PAYING FOR OUR WATER NEEDS THE \$100 FEE AND THE \$15.6 MILLION PLAN

A project-management and funding review of Grand Lakes MUD No. 2's 10-Year Capital Improvements Plan, obtained under the Texas Public Information Act

TOMAS ALVAREZ

SOURCES: 10-Year Capital Improvements Plan, October 2025, revised 8/3/2026 (produced by the District, Aug 10, 2026) · Simplified Capital Improvement Plan, next two fiscal years · EVO 10-Year Financial Operating Strategy · FY2027 Proposed Budget · verified 2025 tax statements · comparable 2026 Texas district bond sale

Chart 1 — MUD 2 annual subtotals as printed on the 10-Year CIP grand-total line. The dashed line is the annual revenue from the proposed “Capital Base Fee” — a flat \$100 monthly fee on every home/account, from Scenario 2.

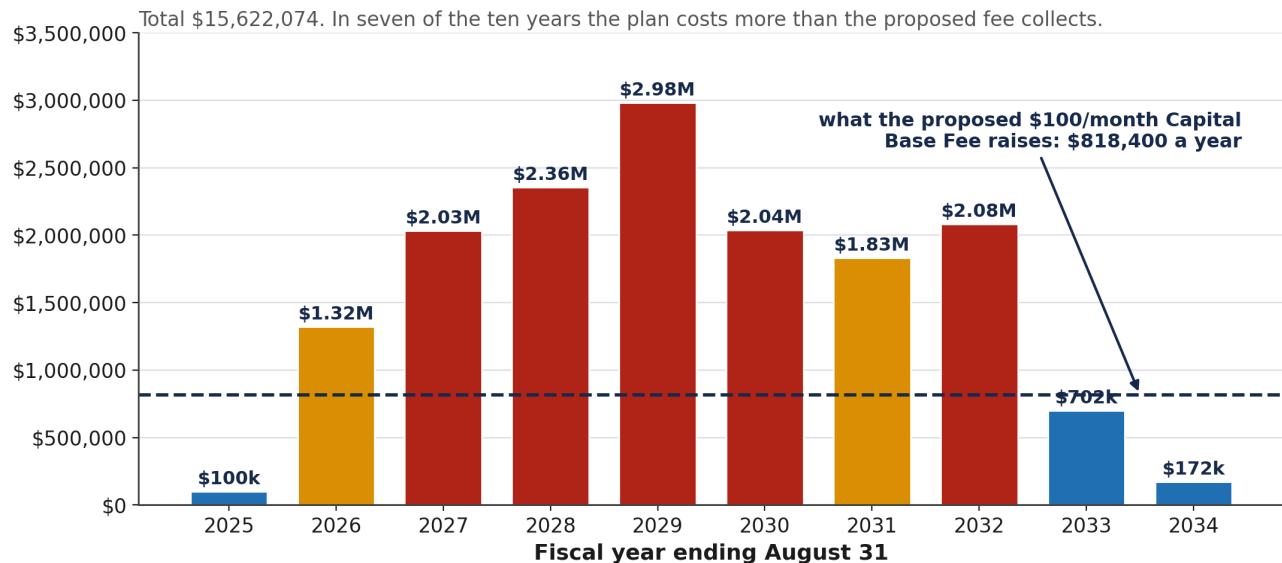
This is the central operational fact. The plan needs an average of **\$1,562,207 a year**. The fee proposed to pay for it collects **\$818,400 a year**. In seven of the ten years the plan costs more than the fee raises, and in the peak year it costs more than three and a half times as much.

The proposed Capital Base Fee is not sized to the plan it is meant to fund. Over ten years it covers about 52 percent of it, leaving roughly \$7.4 million unfunded. This is not a hidden finding — the study itself recommends “planned annual increases of Capital Base fees” if a bond election does not succeed.

Chart 2 — MUD 2’s ten-year share, split by the service life printed against each line item.

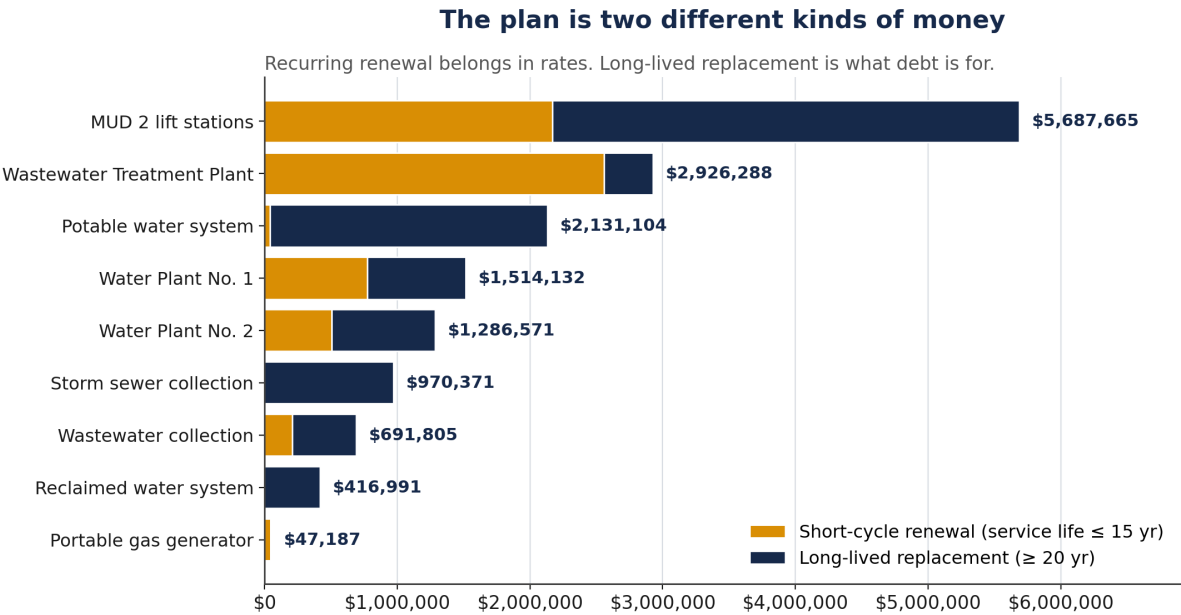
Why the distinction decides the funding question. A ground storage tank coating has a twelve-year life. Financing it over twenty-five years means the District is still paying for the 2027 coating when the 2039 coating and the 2051 coating come due — three obligations stacked on one asset. Recurring renewal belongs in rates, funded through a repair and replacement reserve, precisely because it recurs. The reverse error is just as costly: a 750 kW generator, a motor control centre or a run of buried main lasts twenty-five to fifty years, and charging its full cost to whoever happens to live here in the year it is installed asks today’s households to buy an asset that residents in 2050 will still be using. Debt exists to align who pays with who benefits.

Neither “pay for it all in cash” nor “bond it all” is right, and the argument as it has been conducted assumes it must be one or the other. Pay for recurring repairs from rates, and borrow for the long-lived equipment: roughly two fifths of this plan belongs in rates, and roughly three fifths belongs on bonds.

Chart 3 — Monthly cost to one verified home under each route. Debt at 4.25% over 25 years; see appendix.

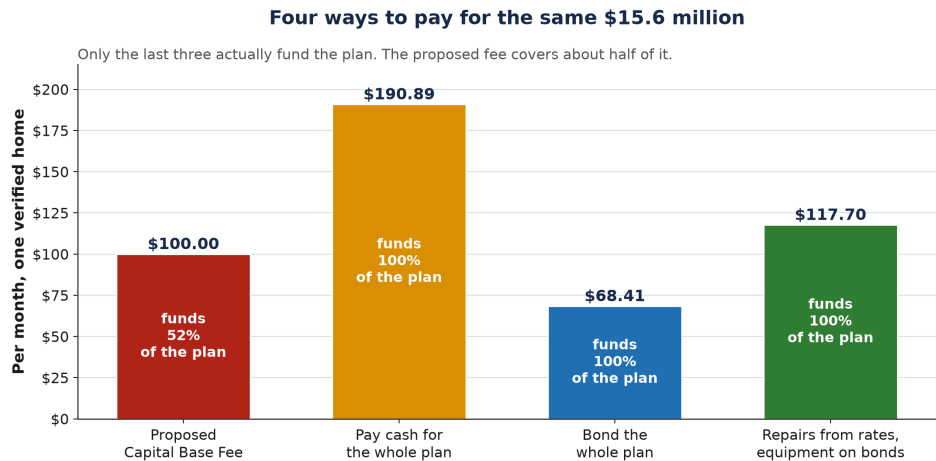
Read the third row honestly. Bonding everything is the cheapest monthly number here, but partly because it stretches ten years of spending across twenty-five and defers cost to people who have not moved in yet. It also costs the most in total: about **\$26.4 million**, roughly \$10.3 million of it interest. Interest is not a trick — it is the price of matching payment to benefit — but it should be stated.

The fourth row is the recommendation, spelled out. Pay for the roughly \$6.3 million of recurring repairs through water rates — about \$76.82 per home/account per month — and borrow for the roughly \$9.3 million of long-lived equipment, repaid through a property tax of about **\$0.1382 per \$100** of taxable value, or \$40.88 a month on the verified home. Together, \$117.70. It funds the whole plan, avoids financing a coating three times over, and — as the next page shows — changes who pays.

Compared like for like — fully funded against fully funded — the choice is between \$190.89 a month on a flat fee and \$117.70 a month under the split approach, for the same work. The proposed \$100 fee is not cheaper than either; it is smaller because it does less.

Chart 4 — Annual capital dollars by payer. Because the District has not published the commercial share of taxable value, it is shown as a range rather than asserted as a figure.

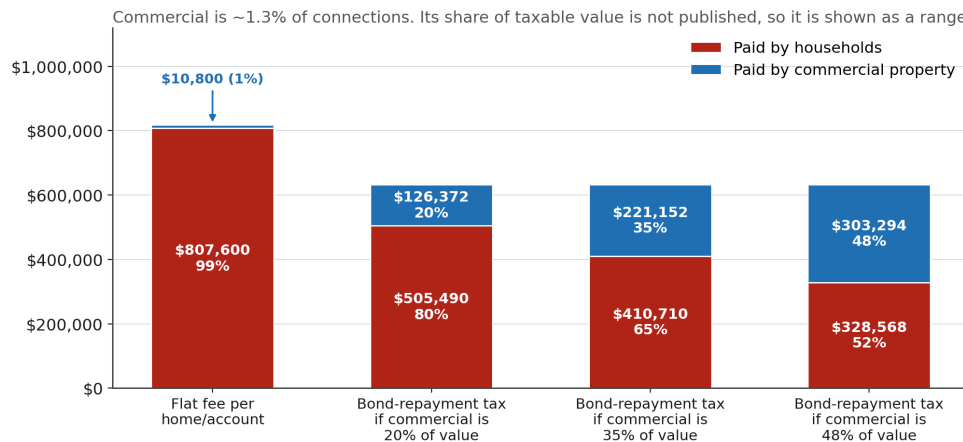
Connections. The August 3 handout's residential table lists **679 meters**; its commercial table names **nine** customers — Walgreens, Firestone, Chase Bank, McDonald's, Jason's Deli, a strip centre, Home Depot, an elementary school and a car wash. That is about **1.3%** of roughly 688 accounts. The District has not published a count; the study's \$818,400 divided by \$1,200 implies 682, which does not reconcile with 679 plus nine. That gap deserves its own question, but the order of magnitude holds: **commercial is around one percent of accounts.**

Value. The District's taxable value is **\$466,651,883**. What proportion is commercial is not stated anywhere in the production, and this brief does not assert a figure. It does not need to: at any commercial share above about one percent, a tax bills commercial property more heavily than a per-account fee does. A flat fee charges per account, so commercial contributes roughly \$10,800 a year out of \$818,400. A tax charges by value. Raising the same \$631,862 a year either way — the property taxes that would repay the bonds — moving from a per-account basis to a tax shifts somewhere between **\$118,000 and \$295,000 a year** off households, depending on that share.

A question this brief cannot answer, and the Board can. What proportion of the District's \$466,651,883 of taxable value is non-residential? That single line from the appraisal roll determines exactly how much of the capital programme a tax would move off households.

Home Depot appears as a single customer in the study's commercial table. Under a \$100 flat Capital Base Fee it would contribute \$1,200 a year toward the plant — the same as a starter home. Under a bond-repayment tax it contributes in proportion to its value, like every homeowner does. This is not a complaint about any business; it is a statement about which instrument the District chooses.

Chart 5 — Monthly cost of the long-lived portion of the plan, flat fee versus the bond-repayment property tax, by taxable value of the home.

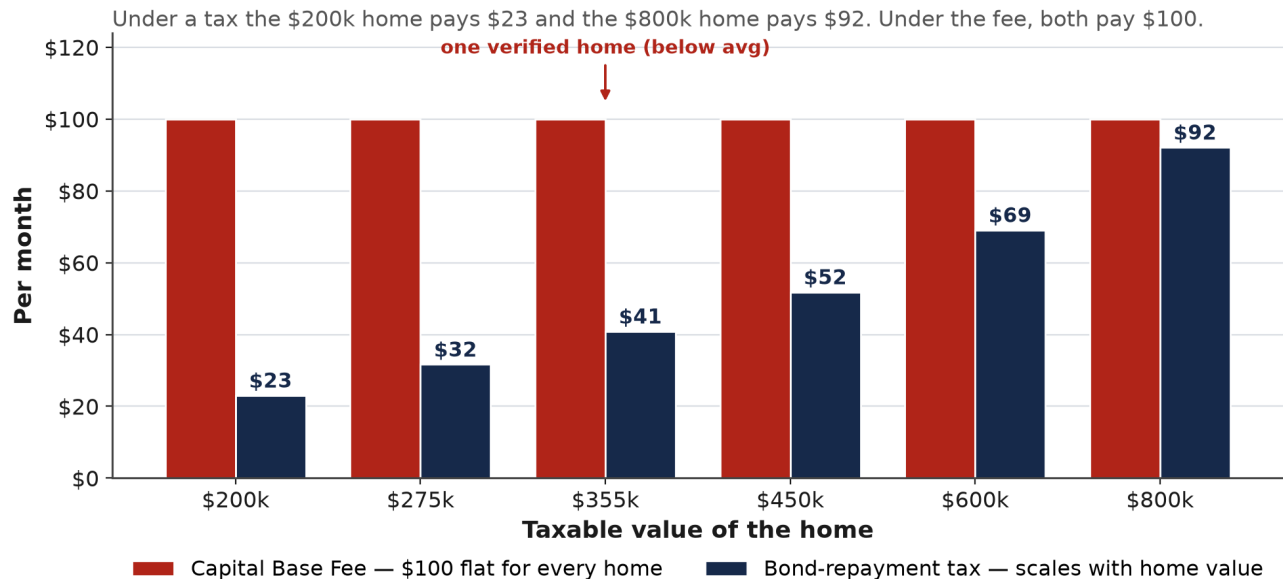
Under the flat fee every household pays \$100, whether the home is worth \$200,000 or \$800,000. Under the bond-repayment tax the \$200,000 home pays \$23.03 and the \$800,000 home pays \$92.11. The break-even is a home with about **\$868,000** of taxable value — well above anything in this community. **Every household below that line pays less under the tax.**

For the great majority of homes in Grand Lakes, funding long-lived equipment through a bond-repayment property tax costs less per month than the proposed flat fee — before the deduction, and materially less after it for households that itemise.
